Groundwater Review Summary Form

Application # G- 18416

PUBLIC INTEREST REVIEW FOR GROUNDWATER APPLICATIONS

A. GENERAL INFORMATION: Applicant's Name: Jackass Mtn. Holdings LLC County: Linn

Water-Level Trends in Nearby Wells

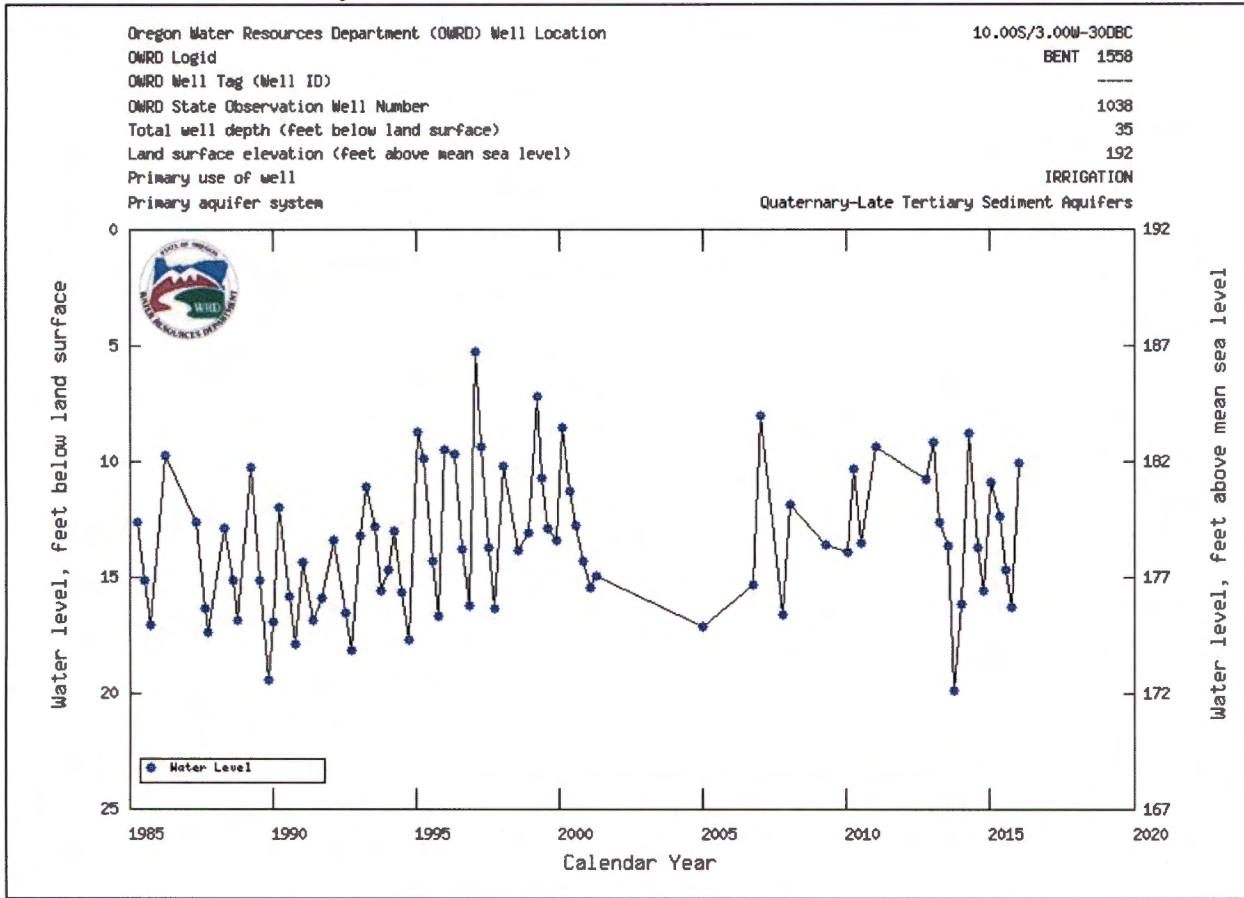
B3. **Groundwater availability remarks:** The proposed POAs will be producing from a layer of alluvium where the Willamette River passes between large outcrops of older marine sediment bedrock to the east and west (Scravel Hill and Spring Hill, respectively). In the area of the proposed POAs there is likely only a few 10s of feet (possibly up to 100) of alluvial material overlying bedrock, according to driller’s logs and maps of bedrock elevation by Woodward et al., (1998). OWRD has SWL data from an observation well nearby (BENT 1558) which is on the other side of the river. These data show generally stable trends over the past three decades but lack of sufficient SWL data on the applicant’s side of the river make it difficult to establish groundwater over-appropriation.

Transient Stream Depletion (Jenkins, 1970; Hunt, 1999)

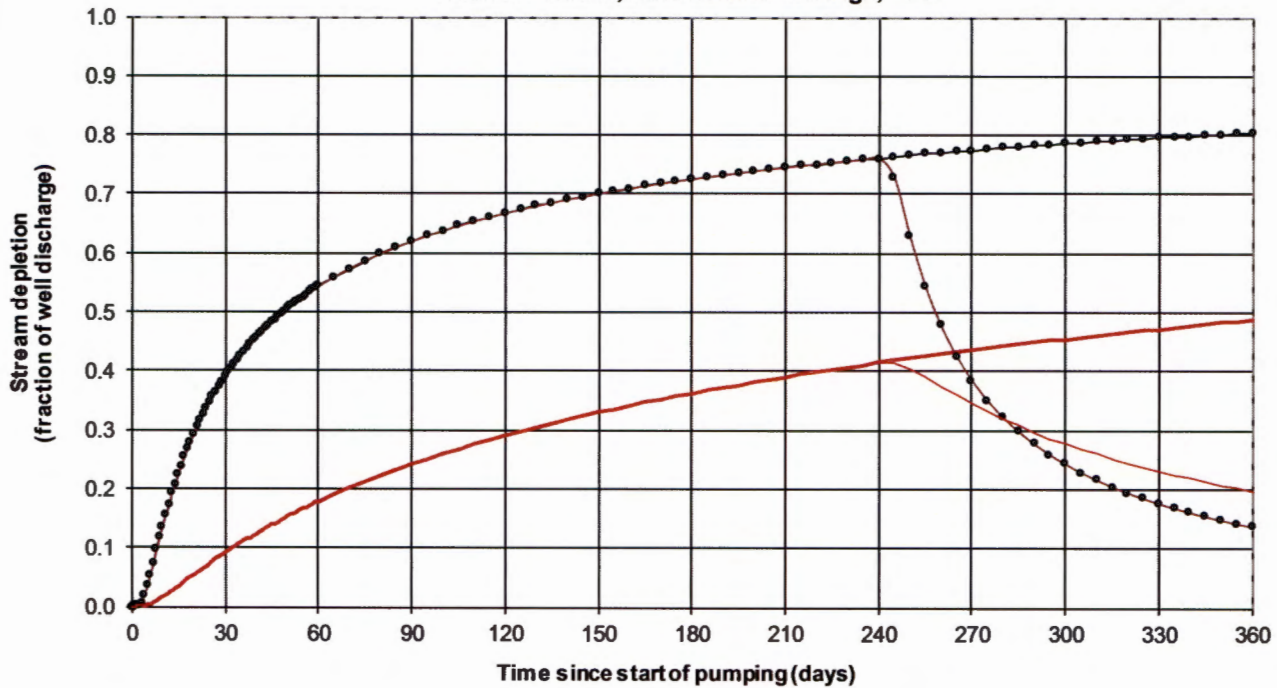
Comments: An analytical model (Hunt, 1999) was used to estimate interference with surface water from Proposed Well #2 (closest to Willamette River) using parameter estimates from Herrera et al., (2014). Impacts from Proposed Wells #1 and #3 are expected to be lower due to their greater distances from the Willamette River. Results (see attachment) confirm conceptual understanding of behavior in an unconfined alluvial aquifer system with high transmissivity.

C6. **SW / GW Remarks and Conditions:** Although the proposed aquifer is strongly hydraulically connected to the Willamette River, the size of the river and nature of the aquifer suggest that there will not be significant interference with surface water per OAR 690-009.
